CUSTOMER NOTIFICATION

SUD-DT-03-0181-2-E
July 31, 2003
Koji Nishibayashi, Senior System Integrator Microcomputer Group 2nd Solutions Division Solutions Operations Unit NEC Electronics Corporation

# IE-V850ES-G1 (Control Code: A, B, C, D, E)

## Operating Precautions

#### No.14 Improvement of power supply block safety

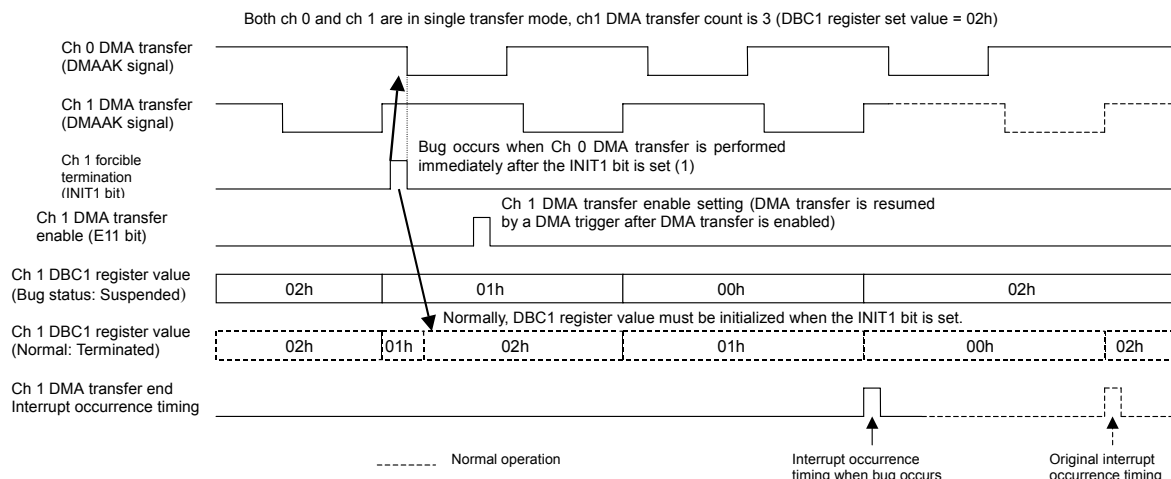
##### [Description]

The safety of the power supply block has been improved.

(There is no safety problem even if this improvement has not been performed.)

This improvement has been implemented in control code C and later products.

## No.21 Restriction that the same branch instruction is traced twice

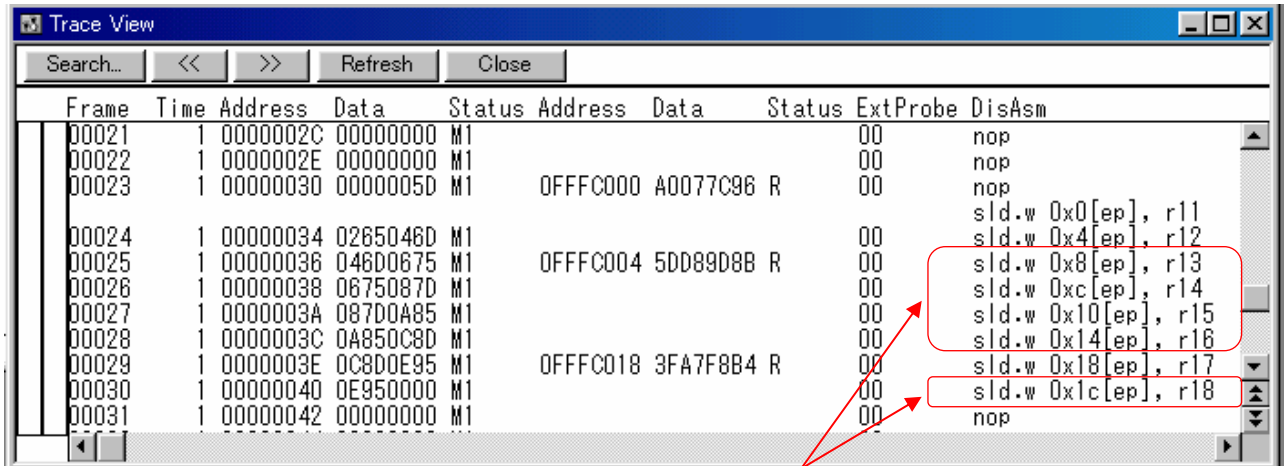
If interrupt generation and execution of a branch instruction (such as JMP, BR, CALLT, or CTRET) conflict, the branch instruction is traced twice.

This restriction affects the trace display only; the actual instruction is executed only once.

—	00000	7	00000240	0000E007	BRM1	00	nop		
—	00001	1	<b>00000242</b>	E0074001	M1	00	<b>reti</b>	←	reti is traced twice if reti conflicts with interrupt generation.
—	00002	2	<b>00000242</b>	E0074001	M1	00	<b>reti</b>	←	
—	00003	2				00			
—	00004	5	00000240	0000E007	M1	00	nop		
—	00005	1	<b>00000242</b>	E0074001	M1	00	<b>reti</b>	←	reti is traced once if reti does not conflict with interrupt generation.
—	00006	2	<b>00000242</b>	E0074001	M1	00	<b>reti</b>	←	
—	00007	2				00			
—	00008	5	00000240	0000E007	M1	00	nop		
—	00009	1	00000242	E0074001	M1	00	reti		
—	00010	4	00001058	0000BF07	BRM1	00	nop		
—	00011	1	0000105A	BF07FEFF	M1	00	jr 0x1058		
—	00012	7	00000240	0000E007	BRM1	00	nop		
—	00013	1	<b>00000242</b>	E0074001	M1	00	<b>reti</b>	←	
—	00014	2	<b>00000242</b>	E0074001	M1	00	<b>reti</b>	←	
—	00015	2				00			
—	00016	5	00000240	0000E007	M1	00	nop		
—	00017	1	00000242	E0074001	M1	00	reti	←	
—	00018	4	00001058	0000BF07	BRM1	00	nop

There is no workaround. Regard this as a permanent restriction.
